## DISCUSSION

### S. E. Arnett<sup>2</sup>

### R. S. Mazzawy<sup>3</sup> and E. M. Greitzer<sup>4</sup>

#### Authors' Closure

Fig. 12 Circumferential growth of stalled region

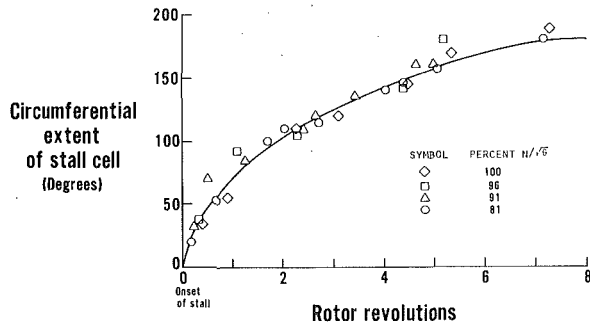
dependent upon the rotor speed as illustrated in Fig. 12. The data in this figure, which is from a three-stage compressor, show the growth of a stall cell as a function of time for different rotor speeds. It can be seen that the growth of the cell appears to scale directly with rotor speed. The task of preventing rotating stall thus becomes much more difficult at high speed because of the shorter times for growth of the stall cells.

A more serious comment is that rotating stall very often precipitates an engine surge. In such cases it is not unusual for the surge to occur in a time of approximately one to two rotor revolutions from the initiation of rotating stall. In a modern gas turbine engine this is on the order of from five to ten milliseconds. Such a situation, which is the more common one at high power, was clearly not covered by the authors' experiments.

As noted in the main body of the paper, the configuration of the J-85 engine limited the test program to engine speeds at or below 80 percent of design speed and hence to relatively low pressure ratios in terms of modern compressors. Thus, the comments by Mazzawy and Greitzer regarding the difficulty of stall recovery at high power are still applicable to the new test results. In fact, the authors are in agreement with these comments provided that rotating stall inception is allowed to occur. However, the results of the latest stall anticipation tests on the J-85 lead us to believe that the control could be applied successfully to modern engines.

Fig. 13 Large hysteresis in stall/unstall phenomenon

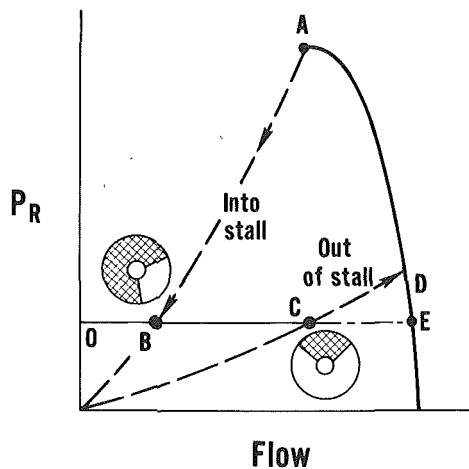
The second area on which we wish to comment concerns the ability to recover an engine from the condition of rotating stall. It is well known that a large hysteresis exists in the stall/unstall phenomenon for a multistage compressor. A sketch of this situation is shown in Fig. 13, and ample documentation of this is provided in [4] (especially the subsequent discussion by J. Harmon which shows data from 22 different multistage compressors). It can be seen that the throttle line (or operating line) must be greatly lowered in order to recover from stall, and, in an engine, this may be very difficult if not impossible to do. The problem is especially acute at high rotor speeds and, in fact, the authors noted this difficulty at the highest speed tested on the J-85 (at 72 percent of design). In other words, the difficulty of recovery increases greatly with speed, and procedures that are effective at low speed may not be at all adequate at high speed.

- 1 substantially improving the response time of engine actuation control mechanisms, and,
- 2 more strongly emphasizing the improvement of recoverability procedures at higher speeds.
